STAFF RECOMMENDATION 119 Windsor Drive September 19, 2012

Application: New construction—addition
District: Belle Meade Links Triangle Neighborhood Conservation Zoning Overlay
Council District: 23
Map and Parcel Number: 13001017500
Applicant: Jeff Steele
Project Lead: Melissa Baldock, melissa.baldock@nashville.gov

Description of Project: Application is to construct a ridge raise and a rear addition.

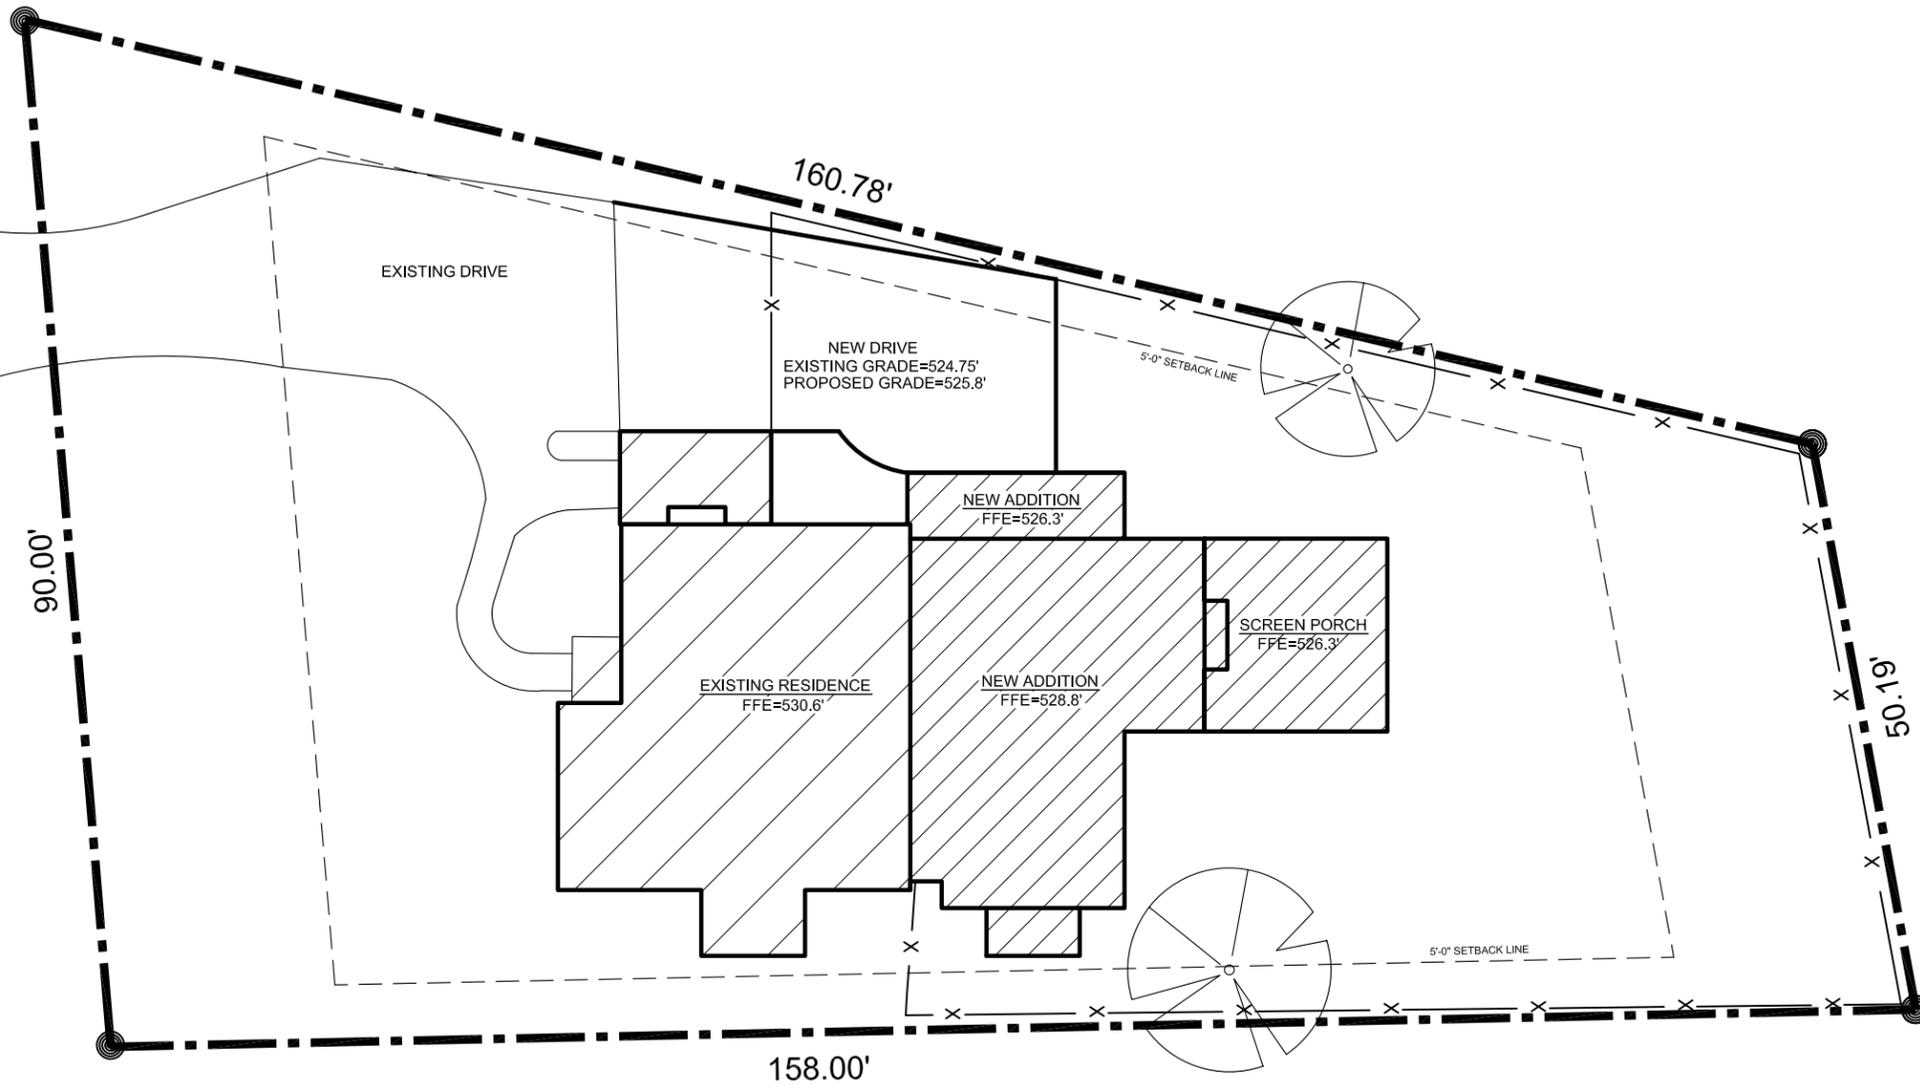
The proposed rear addition meets all base zoning requirements for setbacks, and is located behind the historic structure's footprint. On the right side, the addition initially steps in one foot (1') from the house's back wall for a depth of approximately two feet, nine inches (2'9"). After this depth, the addition extends back out two feet, nine inches (2'9"). This portion of the addition is wider than the back wall of the house, but is still inset from the house's right bay (see photo below). An attached four foot, two inch by eight foot, two inch (4'2" X 8'2") storage area, accessed only from the exterior of the home, will further extend beyond the line of the back wall of the house, but will be no wider than the house's right bay.

The rear addition's right side will extend beyond the back wall of the house but will be no wider than the existing right bay on the historic house.

On the left side, the addition is not inset from the back wall of the house; rather, it extends beyond the back corner of the house by four feet, six inches (4'6"). Although the Commission typically asks that rear additions be inset a minimum of one to two feet (1' – 2') from the back walls of the house, staff finds the lack of an inset appropriate in this instance because of the unusual width of the lot, because the addition is still behind the line of the open side porch at the front of the house, and because the extension is a minor width. The side porch will help minimize the visibility of the wider portion of the addition (see photo below) and the wider portion of the addition is relatively modest in size and scale. It extends just four feet, six inches (4'6") beyond the back wall of the house, is one-story in height, and is more than two-feet (2') shorter than the historic house. Lastly, the addition's side-gabled roof form will also help to reduce the visual impact of the structure.

The addition's right side will not be inset from the side wall of the house, and will extend wider than the house's primary wall. However, the addition will be behind the line of the existing side porch seen here.

Staff finds that the location and setbacks for the proposed addition meet sections II.B.1.c. and II.B.2.a. of the *Belle Meade Triangle Links Neighborhood Conservation Zoning Overlay: Handbook and Design Guidelines*.
